Proposed amendments to Regulation No.53

A. PROPOSAL

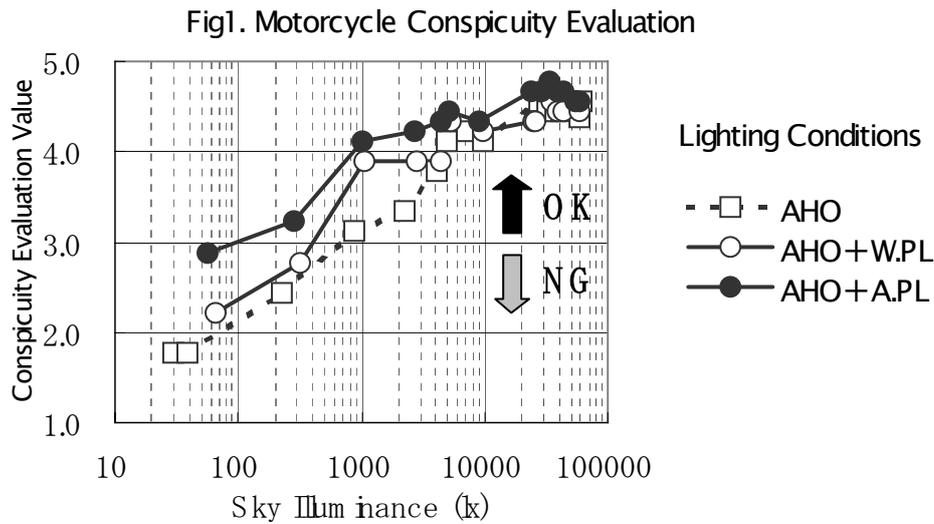
The results of the conspicuity evaluation for motorcycles followed by four-wheeled vehicles with DRL on (Fig. 1) indicate higher motorcycle conspicuity evaluation values for the lighting condition of AHO + amber position lamp than that of AHO only. The effect of the amber position lamp on the improvement of conspicuity is especially prominent under conditions where sky illuminance is low (about 5,000 lm or below). (For details, see “GRE-60-XX.”)

Fig. 2 Motorcycle Conspicuity evaluation

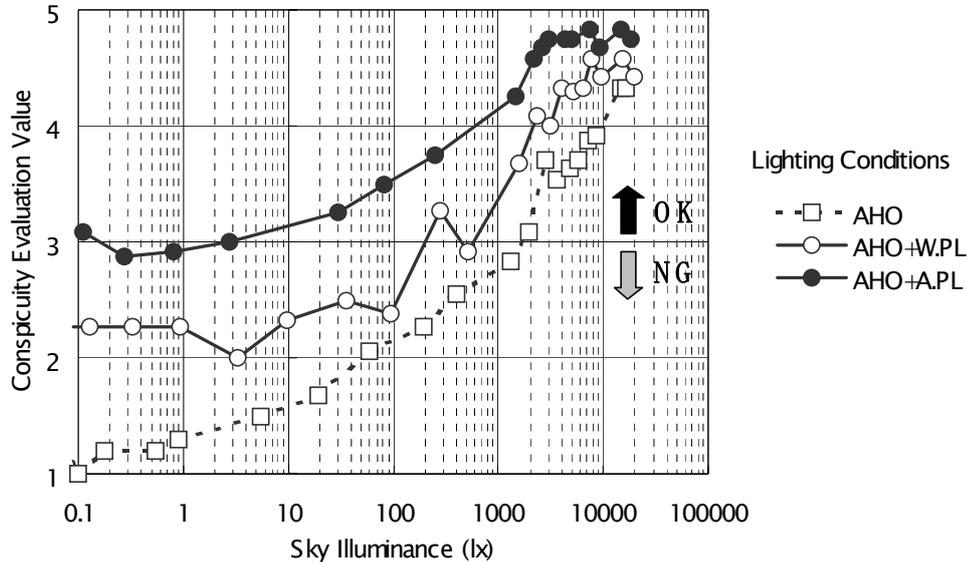
Furthermore, in the case of night driving where four-wheeled vehicles use the passing beam instead of DRL when following motorcycles, the results of the conspicuity evaluation for those motorcycles (Fig. 2) also show higher conspicuity evaluation values for the lighting condition of AHO + amber position lamp than that of AHO only. (For details, see “GRE-60-??.”)
